Access Compliance Report

Public Rights-of-Way

(Curb Ramps)

Intersection ID: 43643	Main Street: HUNTINGTON_MEADOW_LN	Cross Street: SOUTHFIELD_DR	Location: NW
ADA ID: CB566306B54C	Ramp Type: PerpDiag	Initial Pass/Fail: Fail	Overall Compliance: No
Severity Score: 10			
Codes/Mitigation Info/Possible Solution		Field Measurements/Component Compliance

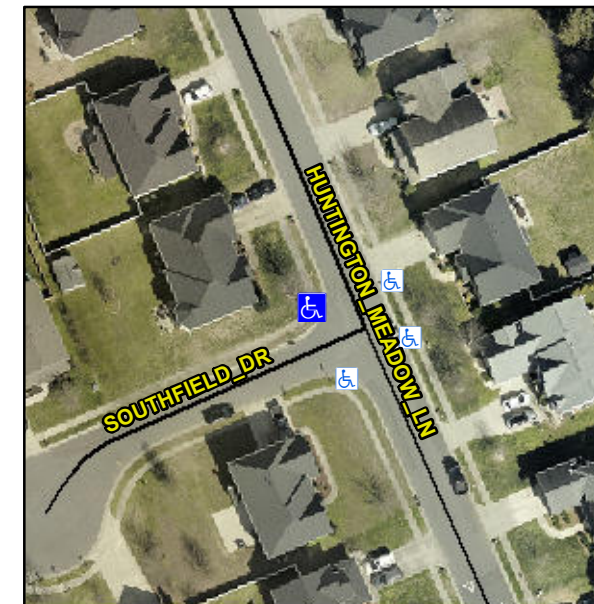
Not Found, R304.5.1, R304.5.3

Compliance	Description	Data	Compliance	Description	Data
N/A	Ramp Length (in)	46.0	Yes	Ramp Slope (%)	7.8
No	Ramp Width (in)	42.0	No	Ramp XSlope (%)	3.2
N/A	Flare Type LT	N/A	N/A	Flare Type RT	N/A
N/A	Flare Slope LT (%)	N/A	N/A	Flare Slope RT (%)	N/A
N/A	Flare Traversable LT?	N/A	N/A	Flare Traversable RT?	N/A
N/A	Landing Length (in)	N/A	N/A	DWS Provided?	N/A
N/A	Landing Width (in)	N/A	N/A	DWS Contrast?	N/A
N/A	Landing Slope (%)	N/A	N/A	DWS Length (in)	N/A
N/A	Landing X Slope (%)	N/A	N/A	DWS Full Width?	N/A
N/A	Landing Curb? (Y/N)	N/A	N/A	DWS Offset (in)	N/A
N/A	Shared Landing?	N/A			
N/A	Gutter Ponding?	N/A	N/A	Gutter Slope (%)	N/A
N/A	Gutter Lip Ht (in)	N/A	N/A	Gutter X Slope (%)	N/A
N/A	Painted X Walk1?	No	N/A	Painted X Walk2?	No
	X Walk 1 Direction	To S		X Walk 2 Direction	To E
N/A	X Walk 1 Width (in)	N/A	N/A	X Walk 2 Width (in)	N/A
	X Walk 1 Slope (%)	0.3		X Walk 2 Slope (%)	1.9
	X Walk 1 X Slope (%)	0.6		X Walk 2 X Slope (%)	1.4

Remove & Replace Curb Ramp With Two New Directional Ramps or Equivalent.
